Final Environmental Impact Report

101
MISSION STREET
OFFICE BUILDING
EE 79.236

FINAL ENVIRONMENTAL IMPACT REPORT

101 MISSION STREET

Figure No. 16

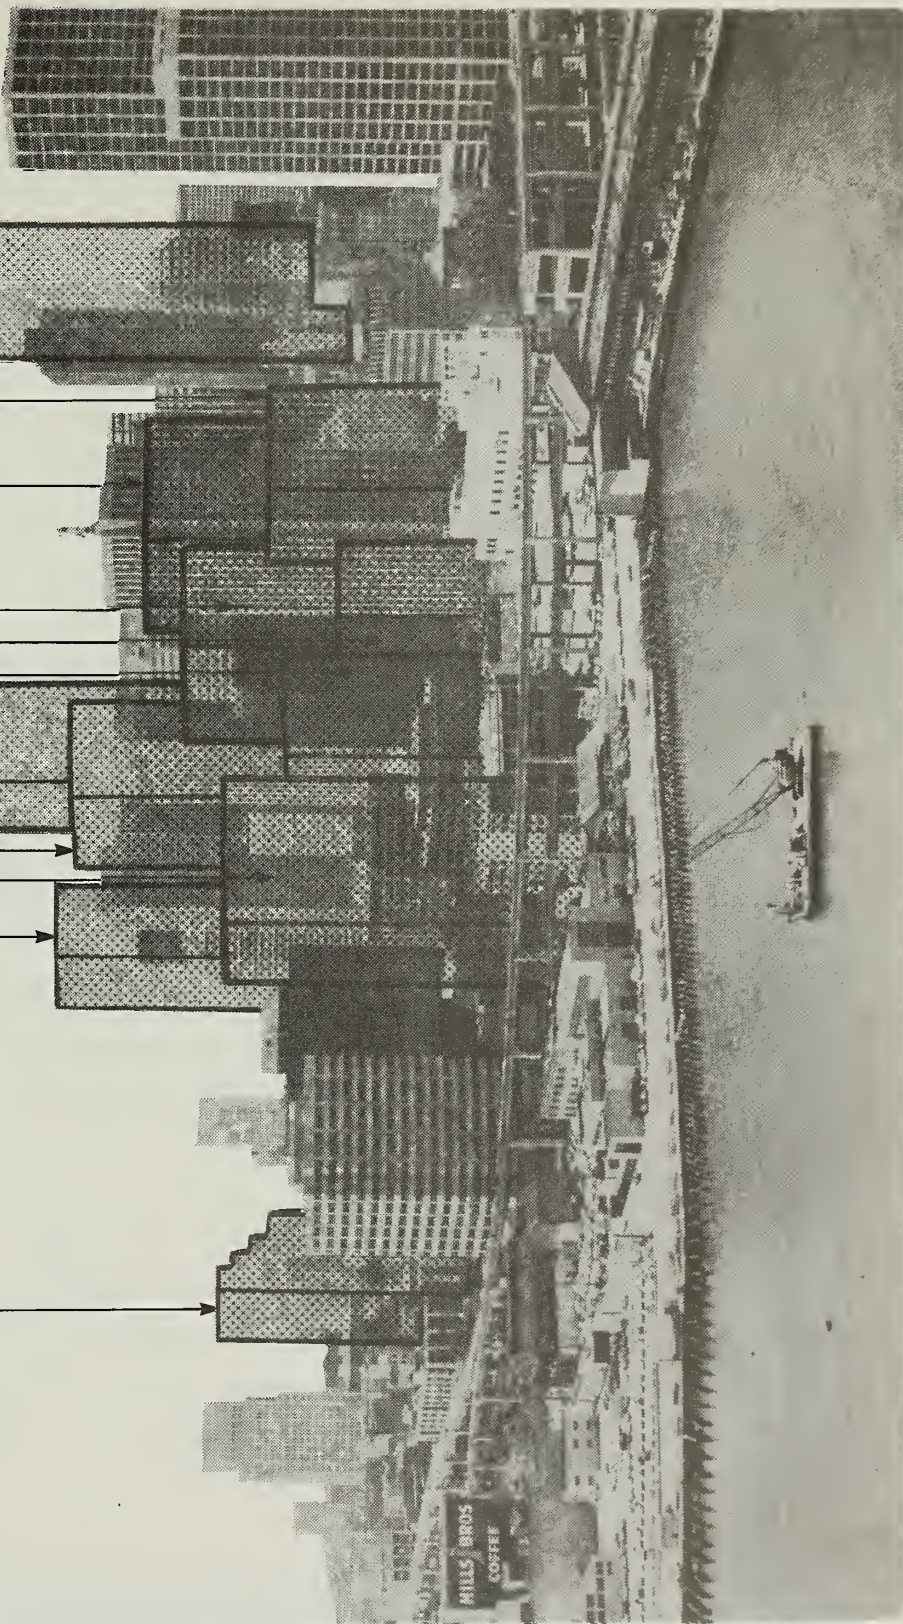
"Figure 16 lacks several major projects: 101 California, the Federal Reserve Bank, Pacific Gateway, Five Fremont Center, Hunt-Knight, the 115-135 Main St. A second such figure is needed for the view from the Lick Freeway from the South, or perhaps from the Main Street bridge ramp complex."

Figure 16 on page 64 has been amended to include the 115-135 Main Street project (EE 81.61) adjacent to the proposed project site, the Main and Mission Street project (81.183E), the 101 California Street project (EE 78.27), the Pacific Gateway project (EE 78.61), the Five Fremont project (EE 80.268), and the One New Montgomery Place project (EE 80.355), also known as the Hunt-Knight project. The Federal Reserve Bank would be screened from view by existing buildings.
